Contract No. T201804301.01
Federal Aid Project No. NH-S018(18)
Georgetown East Gateway Improvements
Sussex County

Enclosed is Addendum No. 2 for the referenced contract consisting of the following:

HV-01
SECTION
WRA
SHEET NO.
16

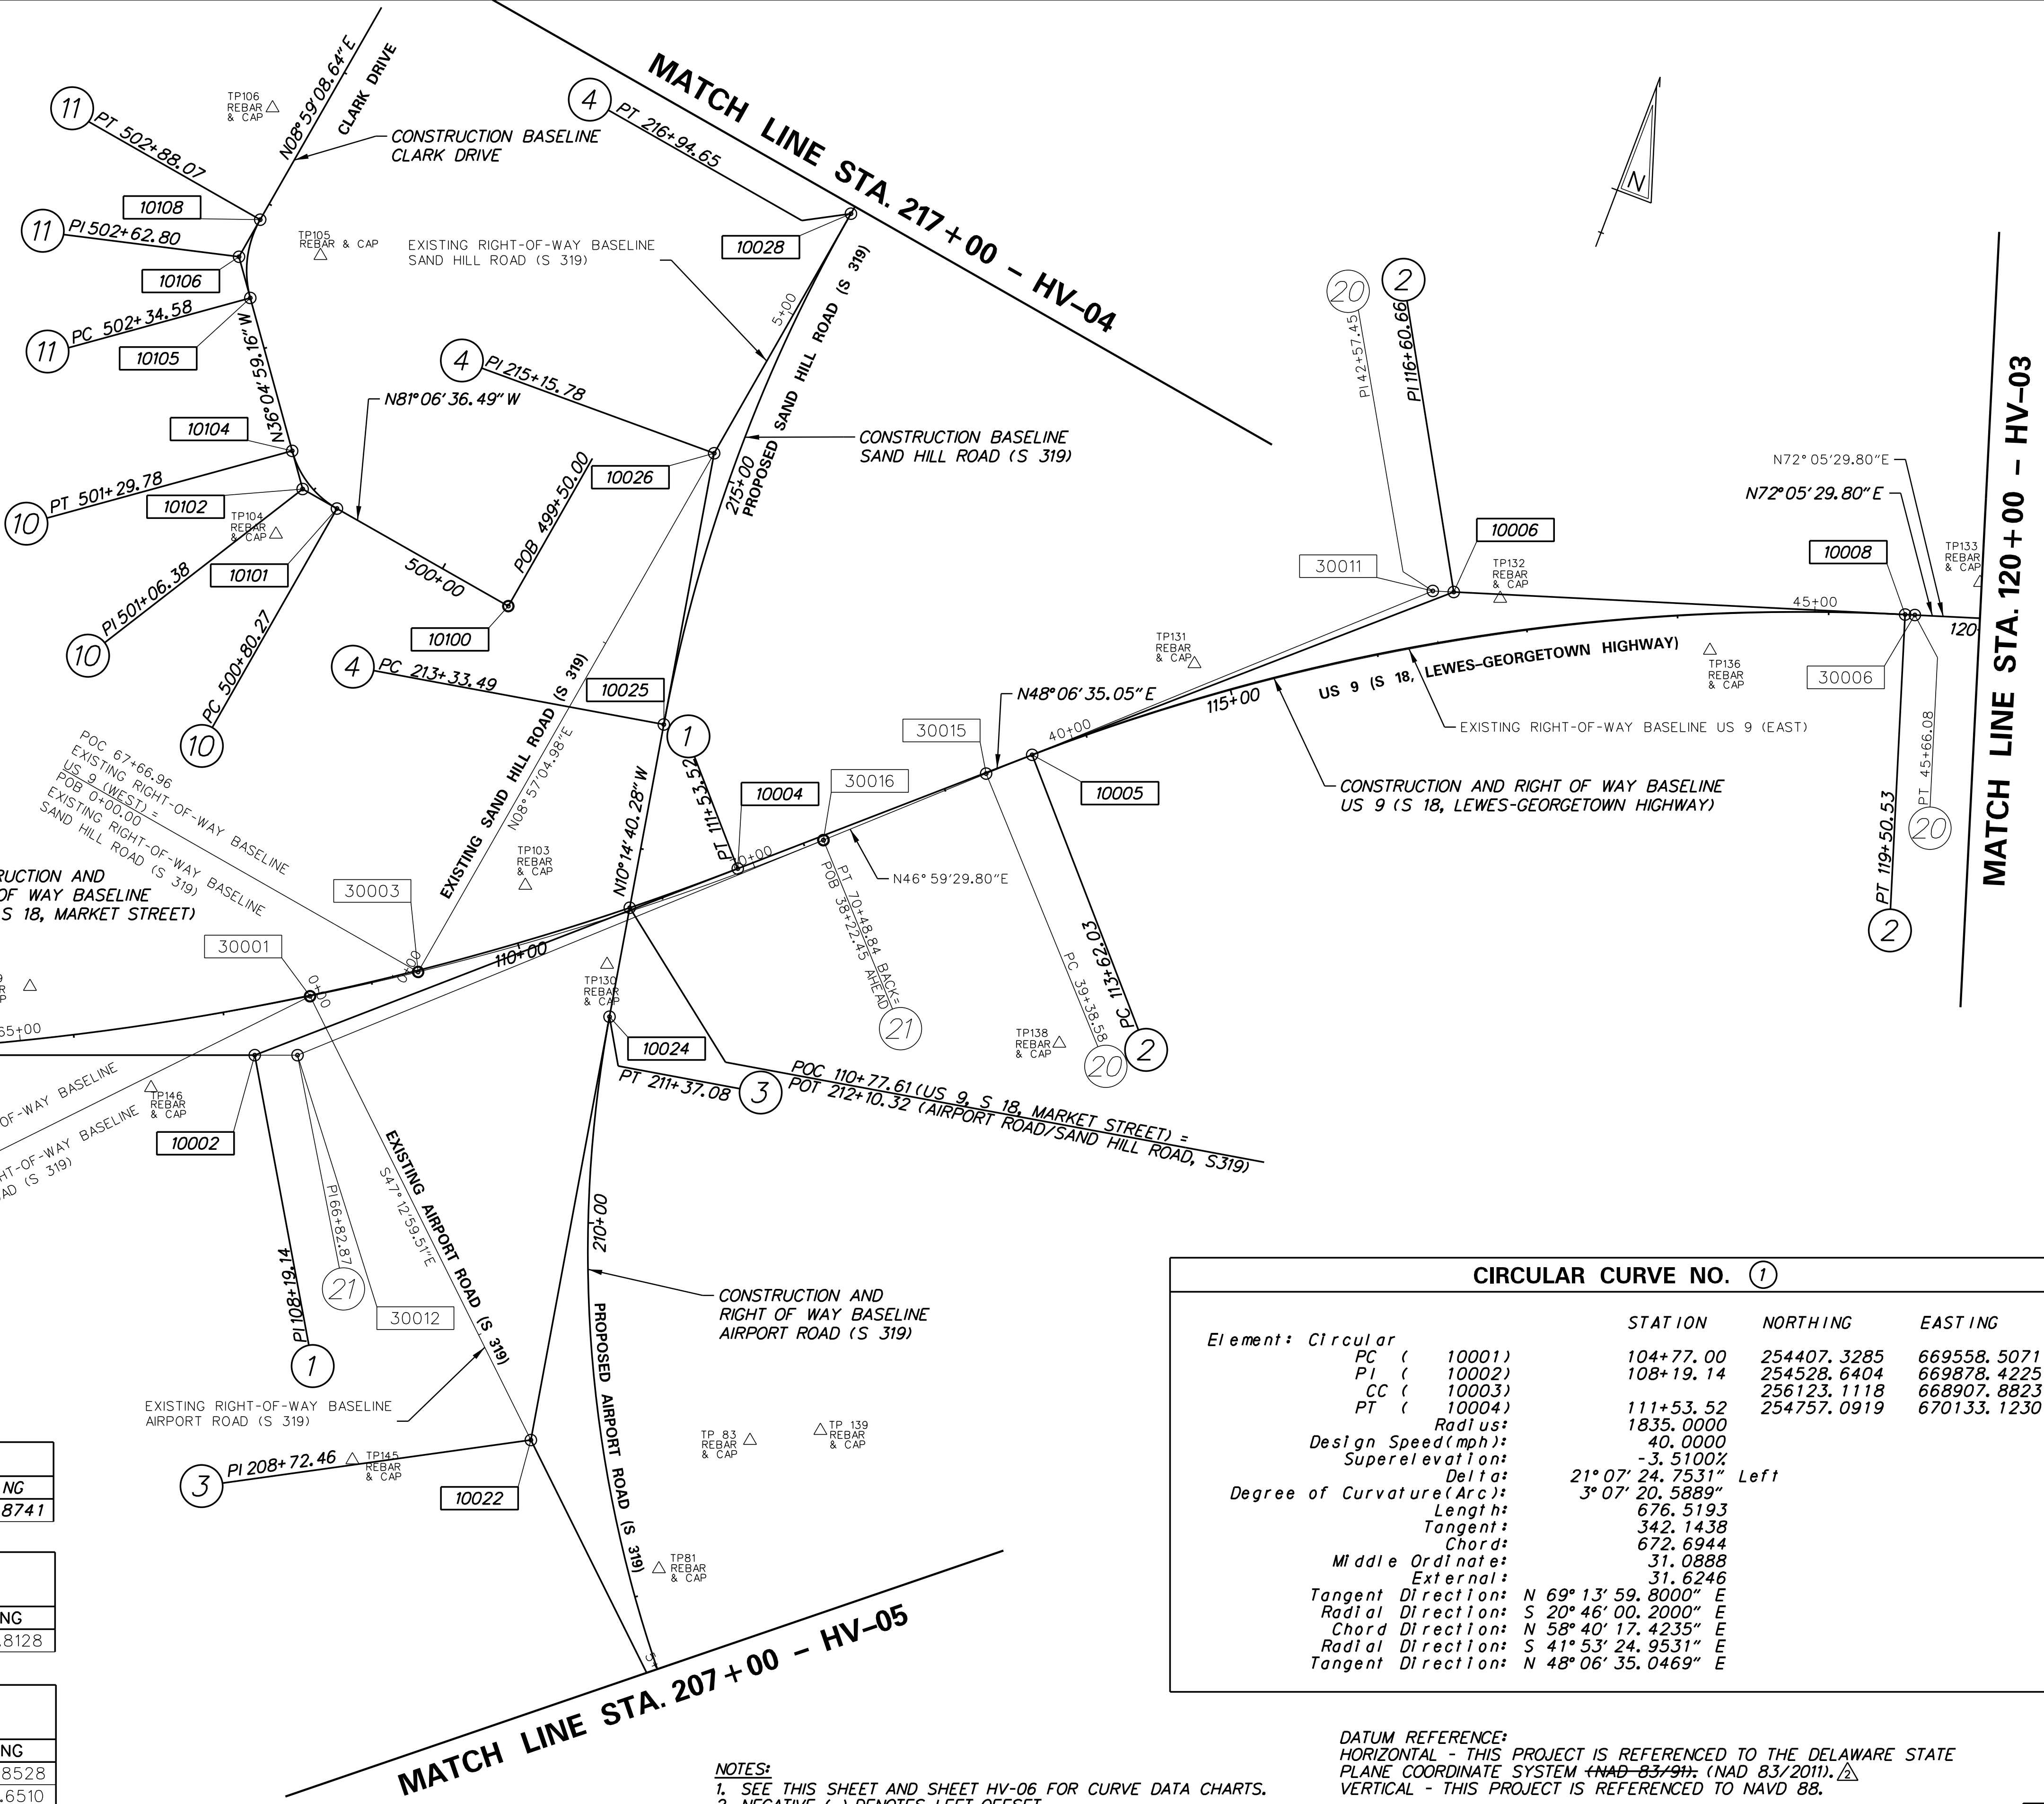
ADDENDA / REVISIONS	
REVISED DATUM REFERENCE NOTE. R. WILLS - 5/1/20

HV-02
SECTION WRA
SHEET NO. 17

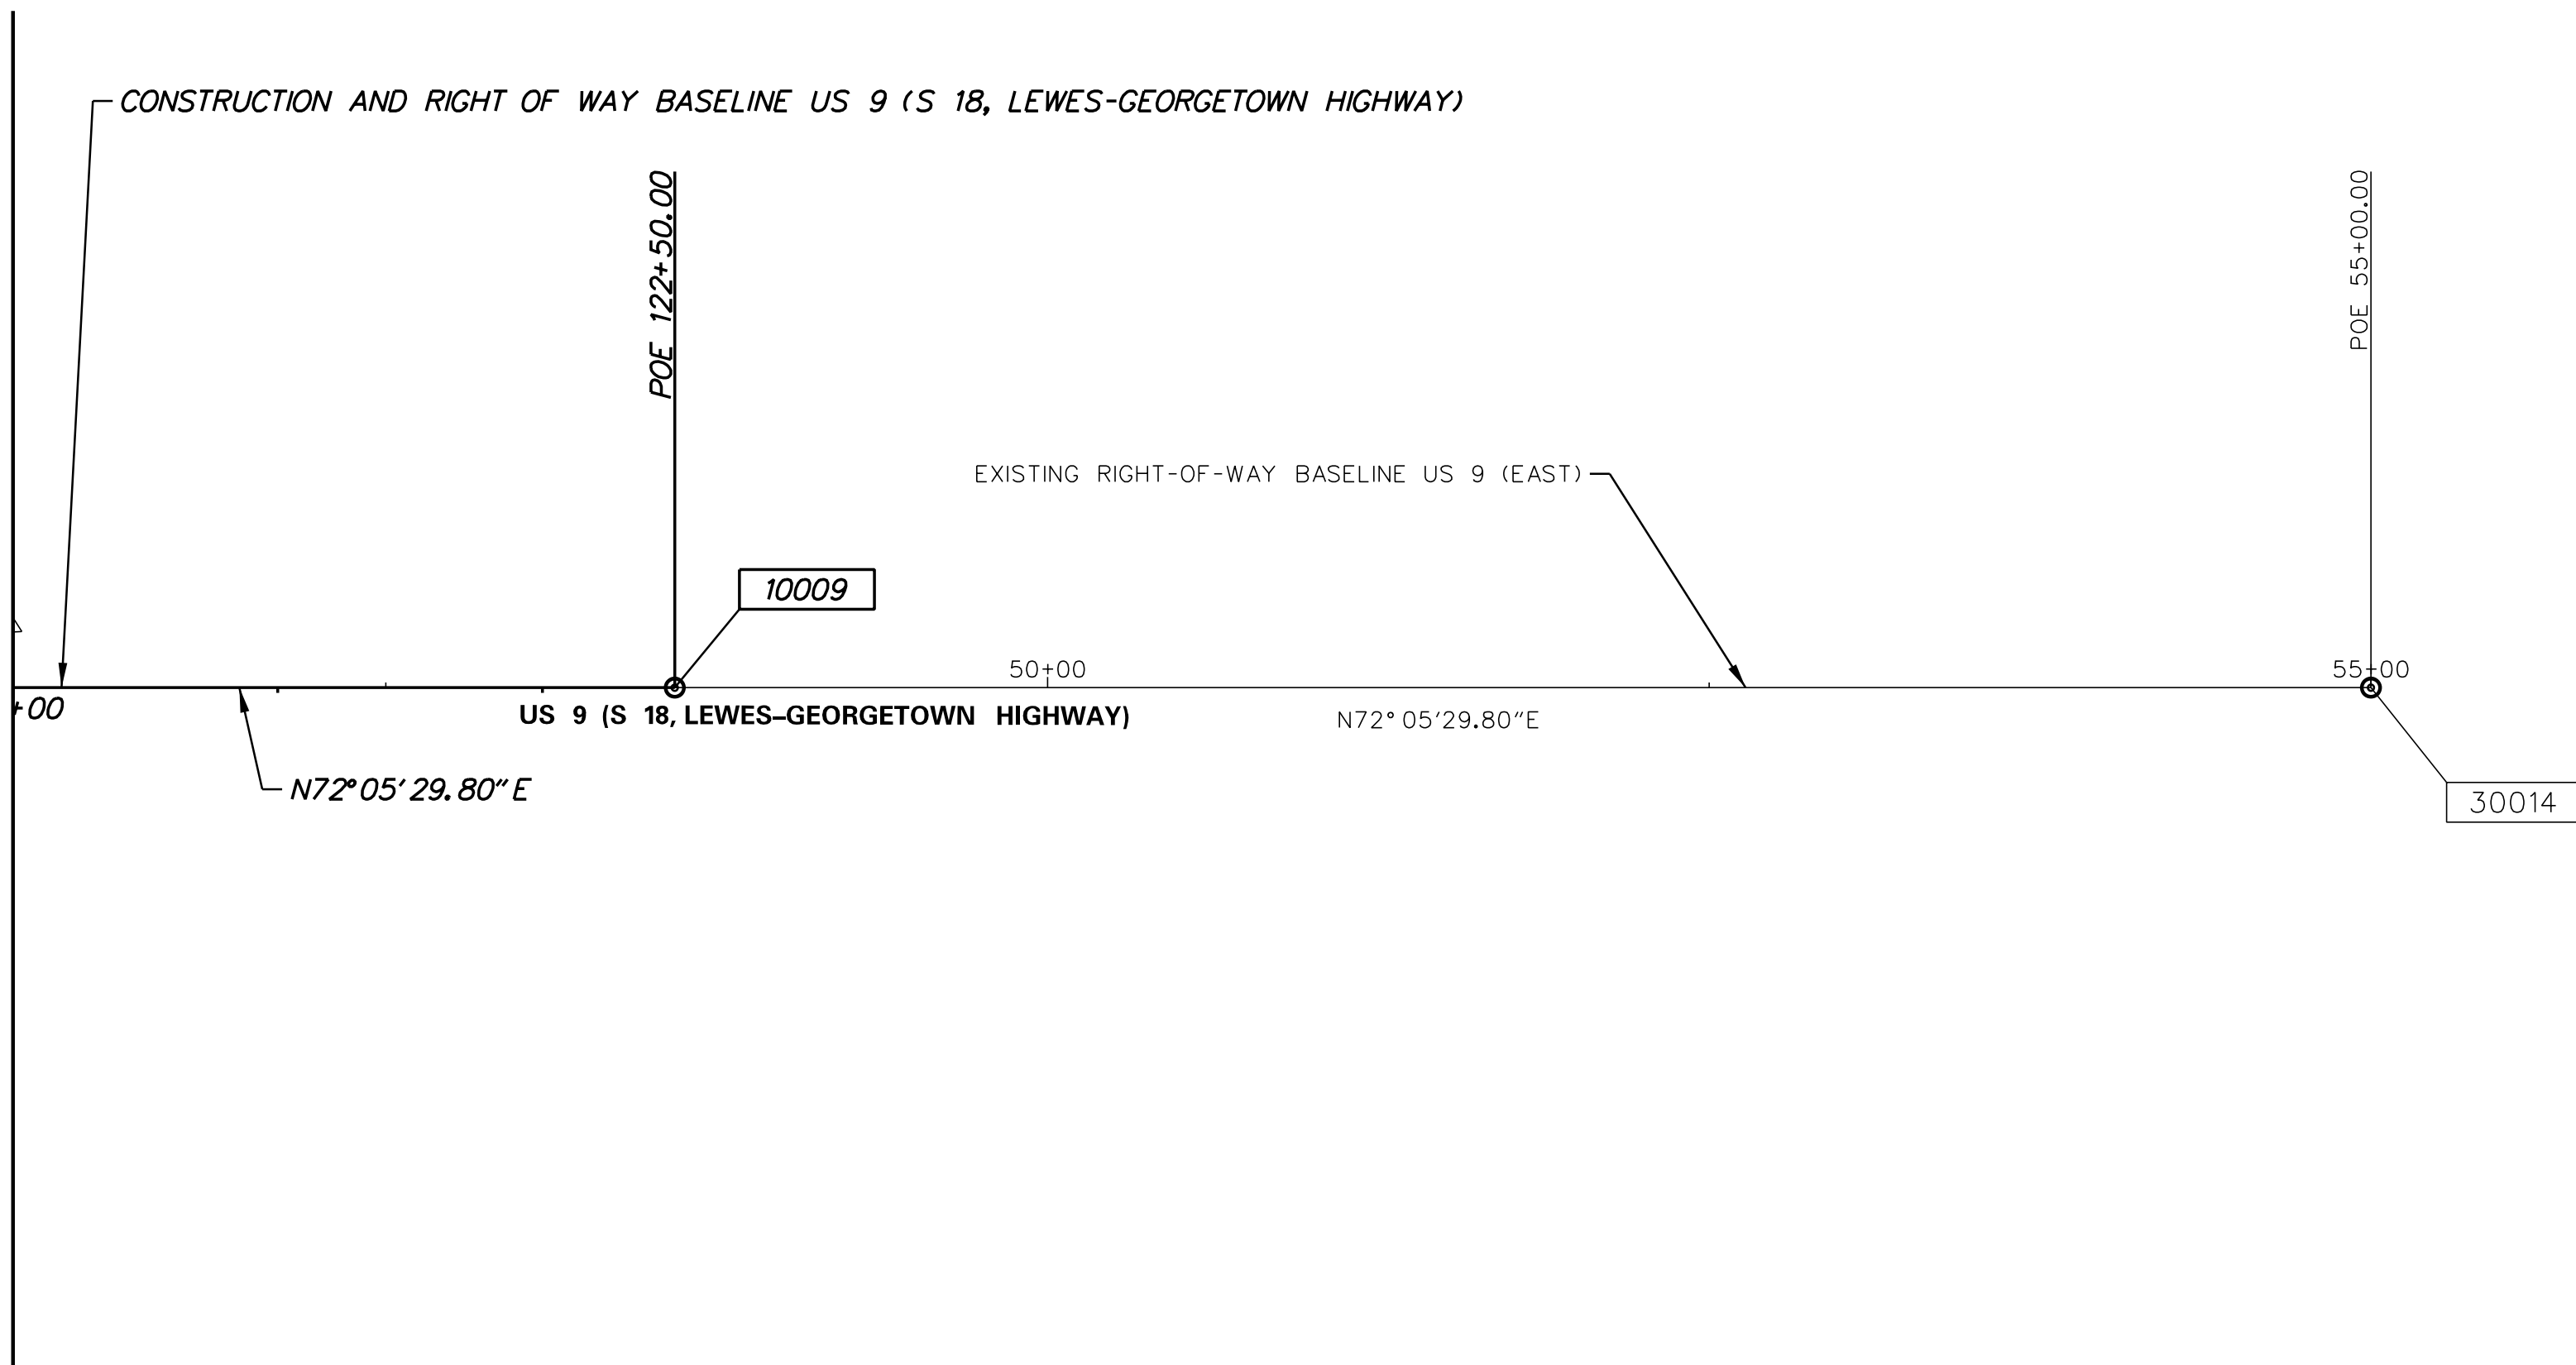
DATUM REFERENCE:
HORIZONTAL - THIS PROJECT IS REFERENCED TO THE DELAWARE STATE PLANE COORDINATE SYSTEM ~~(NAD 83/99)~~ (NAD 83/2011). Δ
VERTICAL - THIS PROJECT IS REFERENCED TO NAVD 88.

ADDENDA / REVISIONS	
△	REVISED DATUM REFERENCE NOTE. R. WILLS - 5/1/20

HV-03
SECTION
WRA
SHEET NO.
18

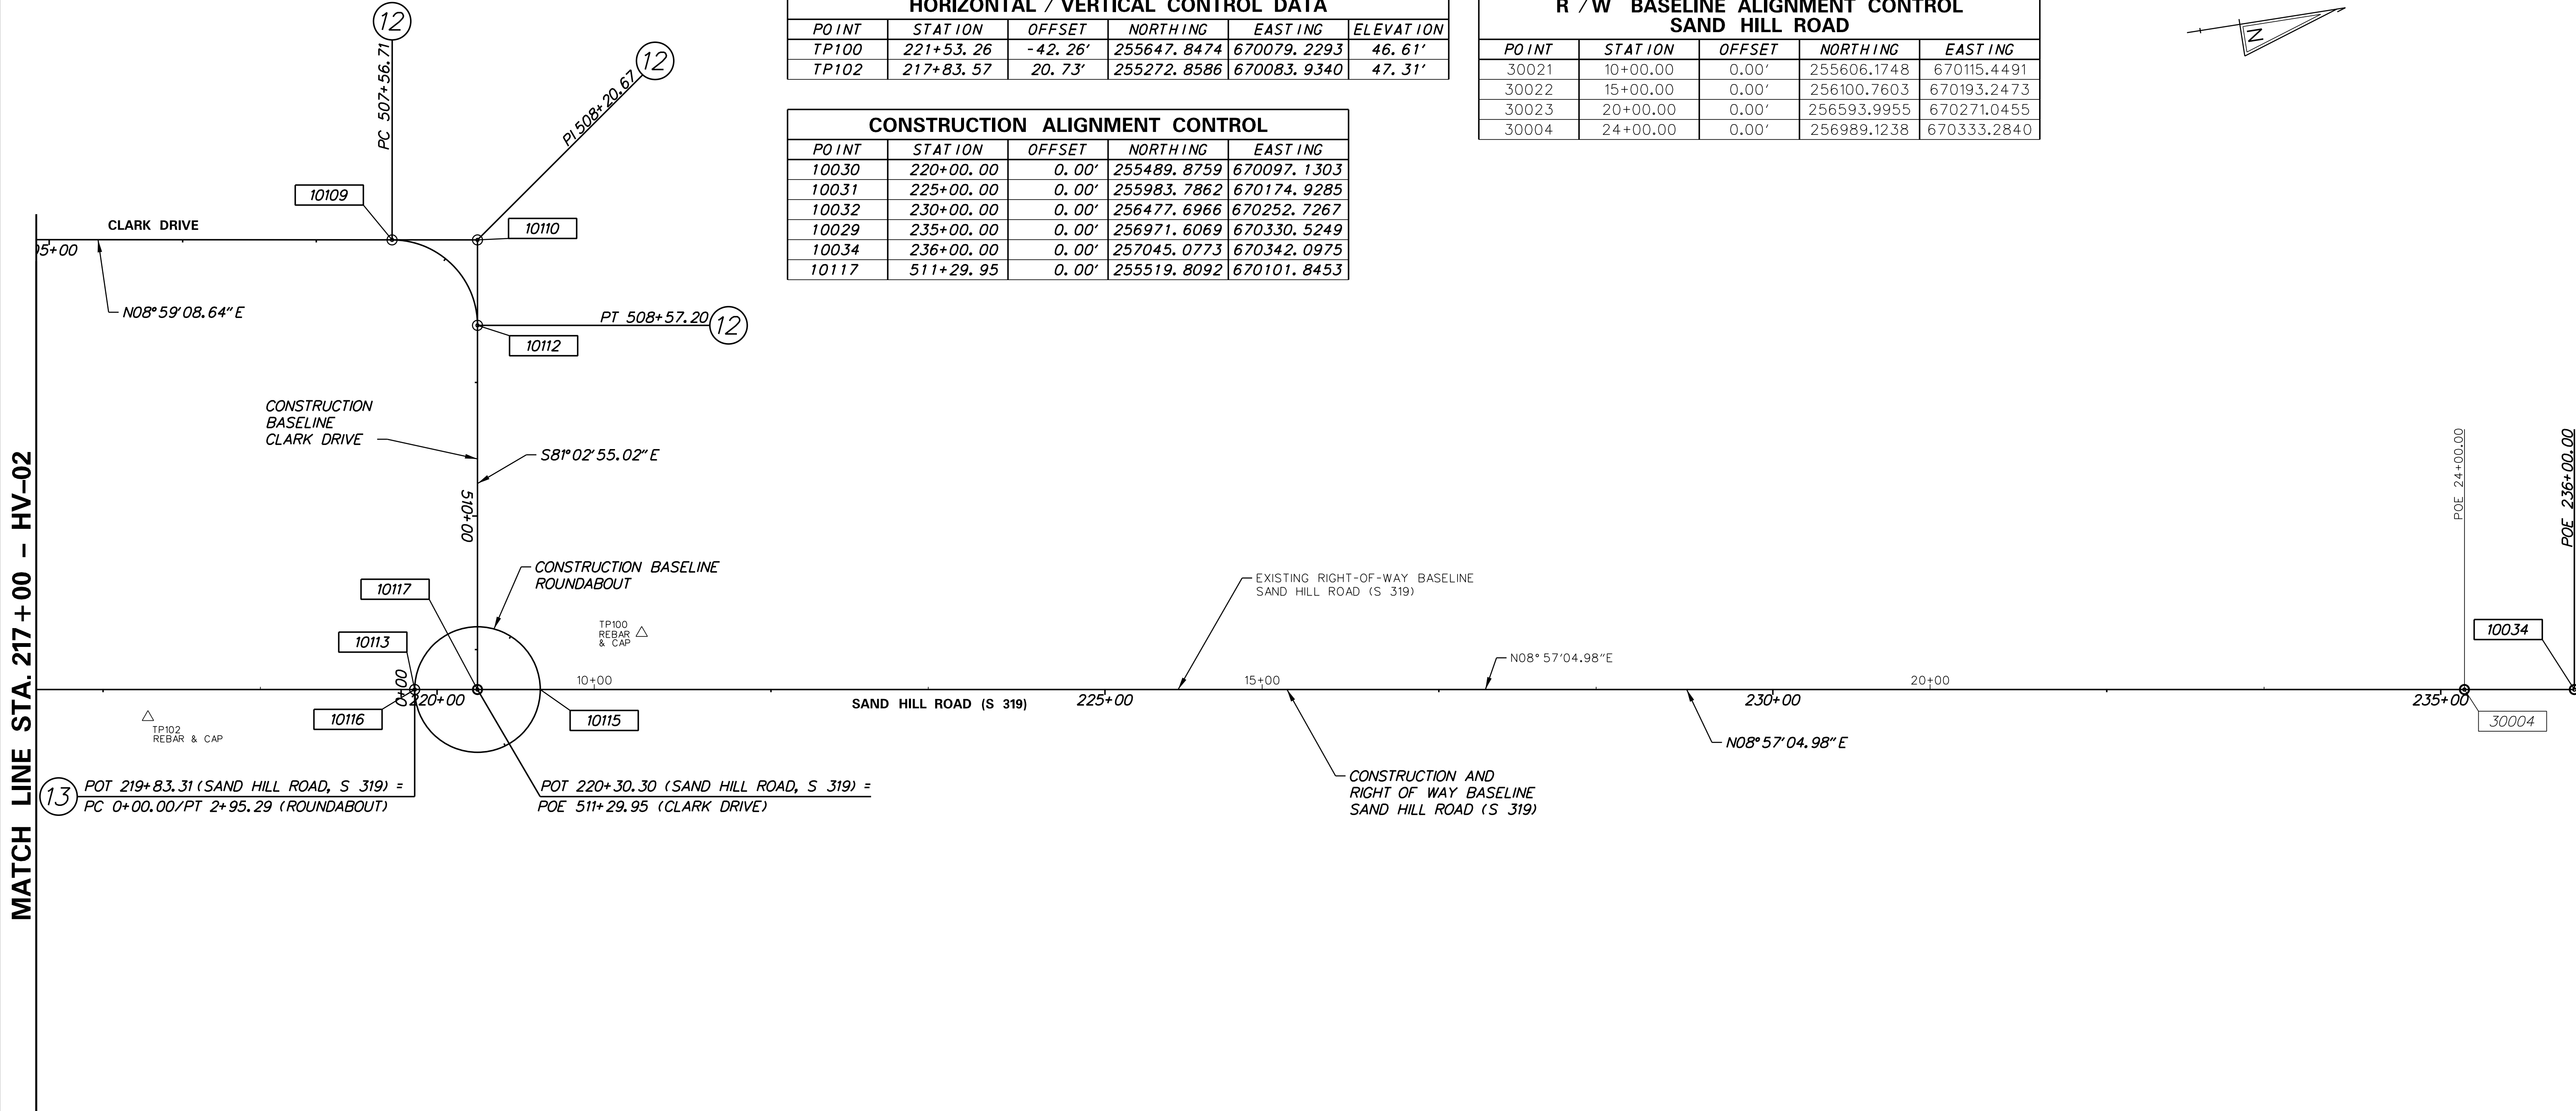
NOTES:
 1. NEGATIVE (-) DENOTES LEFT OFFSET.
DATUM REFERENCE:
 HORIZONTAL - THIS PROJECT IS REFERENCED TO THE DELAWARE STATE PLANE COORDINATE SYSTEM (NAD 83/91); (NAD 83/2011).
 VERTICAL - THIS PROJECT IS REFERENCED TO NAVD 88.

ADDENDA / REVISIONS
REVISED DATUM REFERENCE NOTE. R. WILLS - 5/1/20
